CERTIFICATE OF APPROPRIATENESS**Application Date:** November 3, 2025**Applicant:** Anthony Monaco, owner

Property: 2924 Watson Street, Lot 2, Block 1, Woodland Heights Neighborhood Subdivision. The property includes a vacant 5,670 square foot interior lot fronting Watson Street. The lot was approved for replat by the City of Houston Planning Commission to subdivide the 11,325 square foot corner lot into two 75' x 75.6' parcels (728 Euclid and 2924 Watson Street). The plat was recorded on 11/14/2025 (Film Code No. 713687 of the Map Records of Harris County).

Proposal: New Construction – Single Family Residence with an Attached Garage

WEST ELEVATION - FRONT FACING WATSON

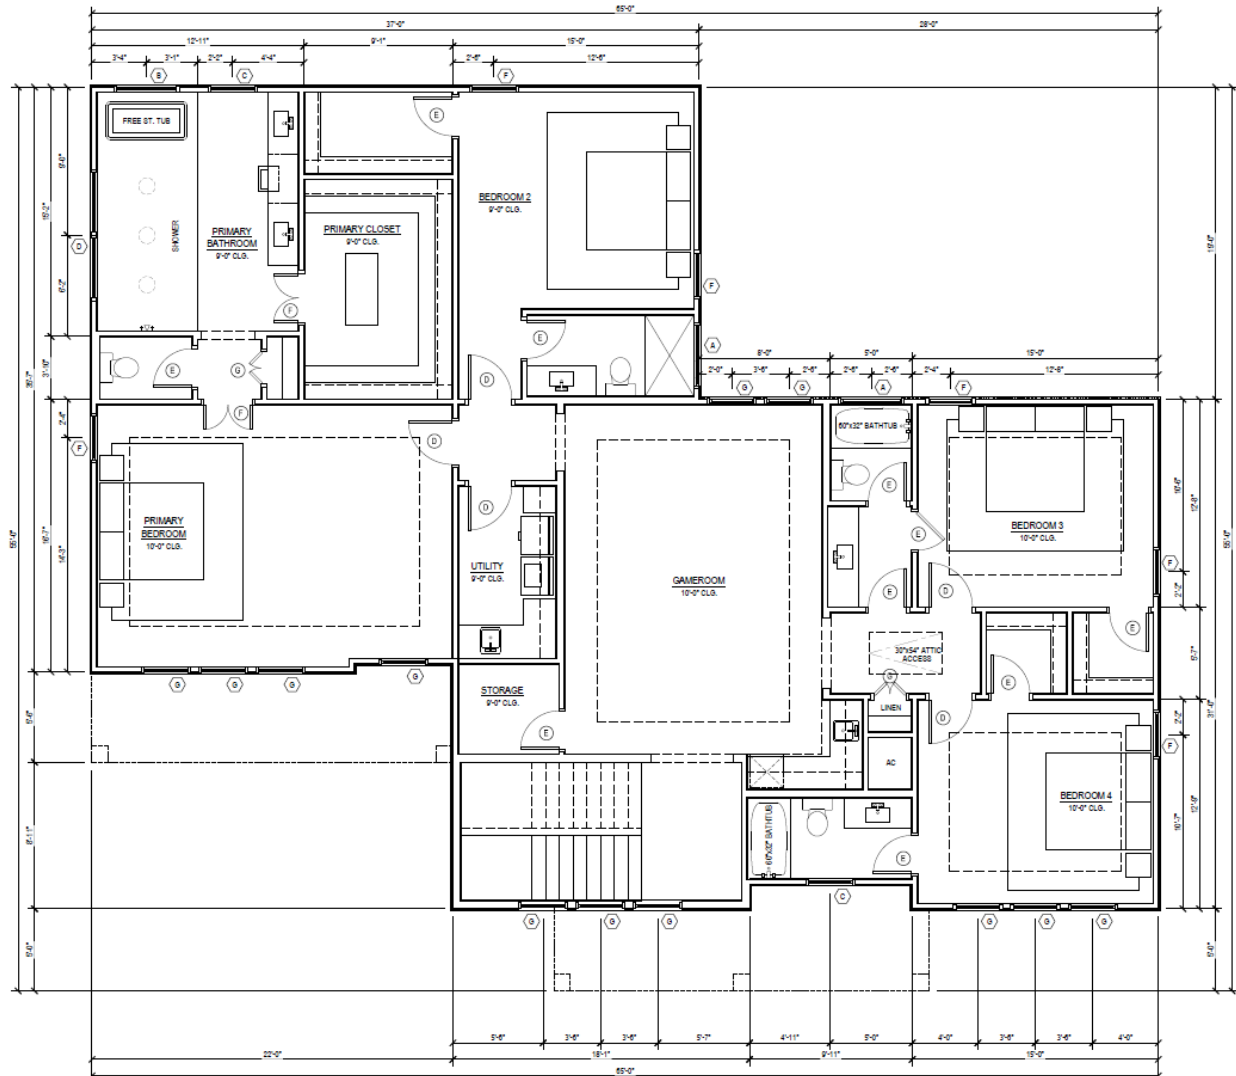
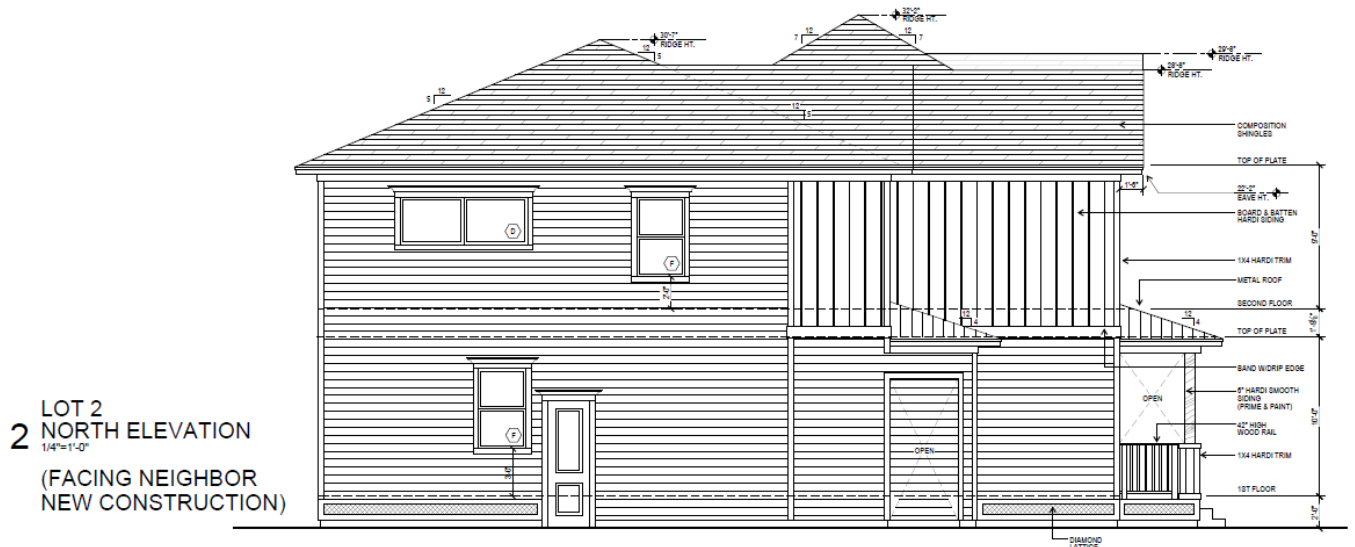
The new construction has an overall maximum ridge height (32'-2") which does not exceed the typical height of existing contributing structures on the 700 block of Euclid near the site (which is approximately 34'-0").
